PLAN COMMISSION

February 14, 2023

AMENDED

Proposal: Plan Review – Multitenant Industrial Building

Date:	08/16/2022	Revision:	
Drawn:	MA	Checked:	KB
Date:	08-16-2022	Date:	08-16-2022
Scale:	AS SHOWN	Scale:	AS SHOWN
Project:	3409	Project:	3409
Sheet:	L1.0	Sheet:	L1.0

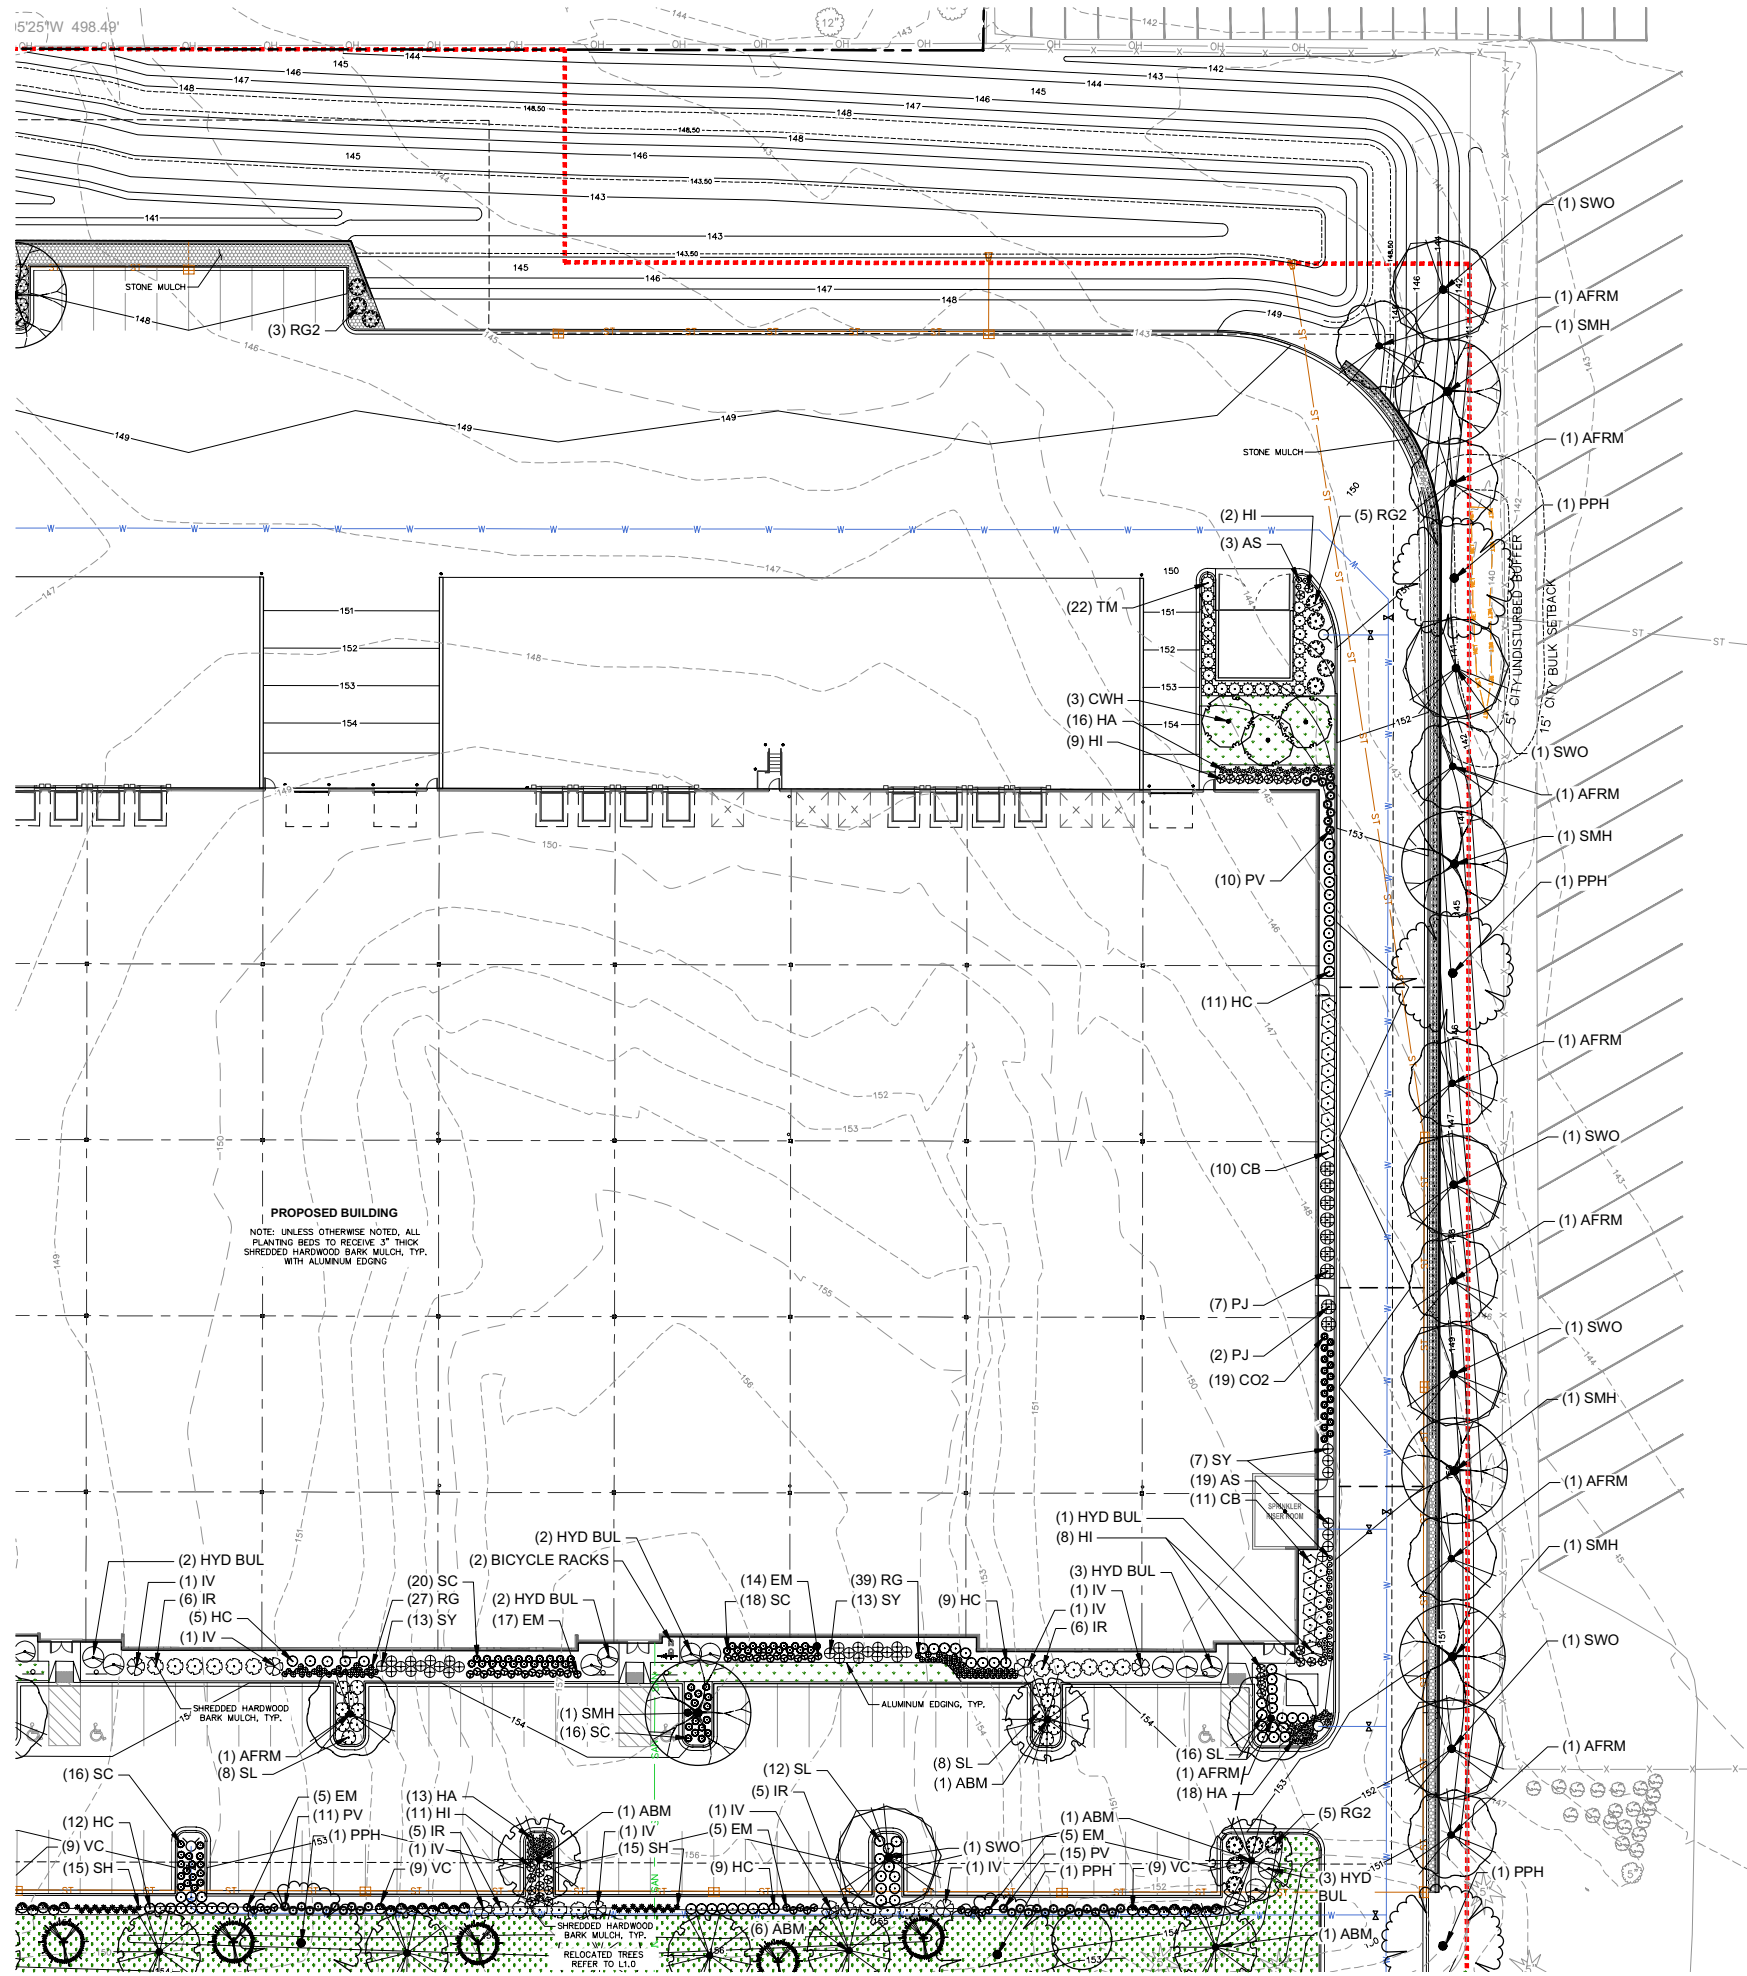
- Several trees along the east property line identified for removal may not be located entirely on the development parcel. If the trees are to be removed, they must be verified as being on the development parcel or there must be a signed agreement with the property owner to the east detailing the removal and restoration plan.

- The Tree Inventory identifies 21 trees in “good” condition meeting the criteria for replacement per Code. However, considering the 20 trees fully contained on the development parcel, Code requires a minimum replacement of 3:1, or 60 trees. Plans indicate that 27 trees will be replaced and 27 trees will be planted to account for the removed trees. Therefore, the replacement plan is short by six (6) trees.

- Landscape plans have been revised to include labels and planting heights at installation. Further revisions will be required for Code compliance, including the requirement for all parking lot screening materials to be installed at a minimum height of three (3) feet, islands to have a minimum soil depth of 36 inches, and for ground-mounted mechanical units to be screened such that a maximum of 20% is visible through the screening materials.
